30-045-22565 UTE INDIANS A #010

HILCORP ENERGY COMPANY

HILCORP ENERGY COMPANY
UTE INDIANS A 10
NOTICE OF INTENT TO PERMANENTLY ABANDON

CONDITIONS OF APPROVAL FOR NOIA SUNDRY DATED 010620

WELLBORE DIAGRAM - PROPOSED

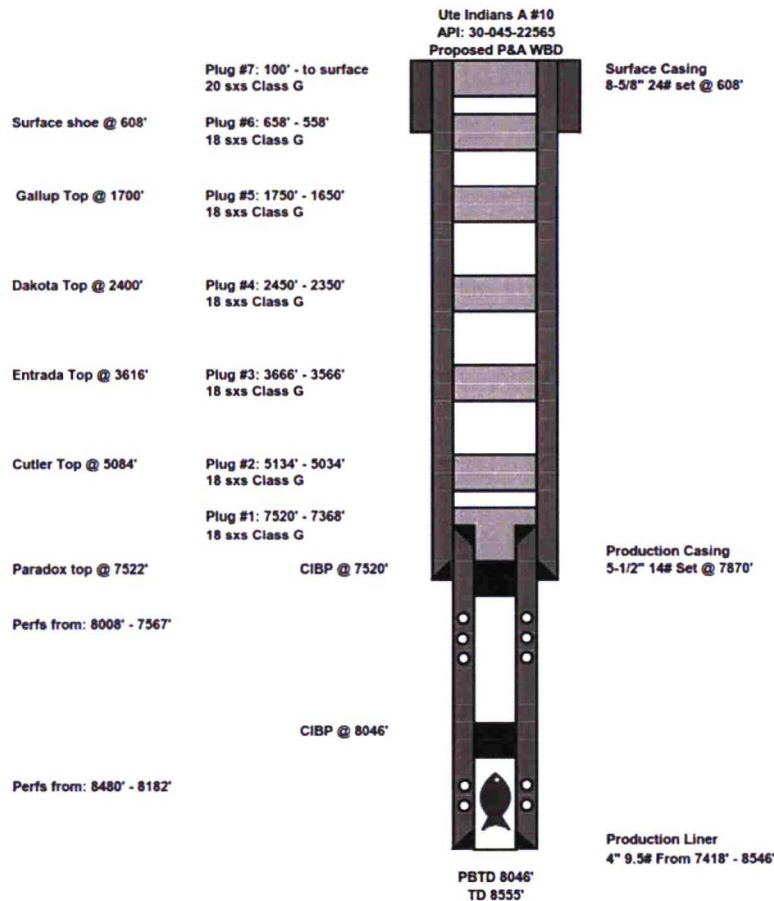
- Add a Mancos plug 724'-558' (combining with the casing shoe plug). OCD Mancos pick @ 674'.
- Extend Plug #4 to 2525'-2350' to cover the Morrison top. OCD Morrison pick @ 2475'.
- Add a Chinle plug 4120'-4020'. OCD Chinle pick @ 4070'.
- Add a Hermosa plug 6620'-6520'. OCD Hermosa pick @ 6570'.

3. **Plug #4 volume to be increased 2X (36 sx) to insure coverage of squeeze hole and DV tool at 2287'.**
4. **Plug #6: Perforate approximately 25'-50' below casing shoe at 608' and attempt to squeeze cement to surface. If circulation cannot be established place a balance plug from 50' below squeeze perforations to 558'. Plug #7 to be place as stated.**

5. **Operator may also opt to place a continuous balance plug from 50' below Plug #6 squeeze perforation to surface and eliminate Plug #7.**
6. Third party contractors are to be aware of these conditions of approval and adhere to them.
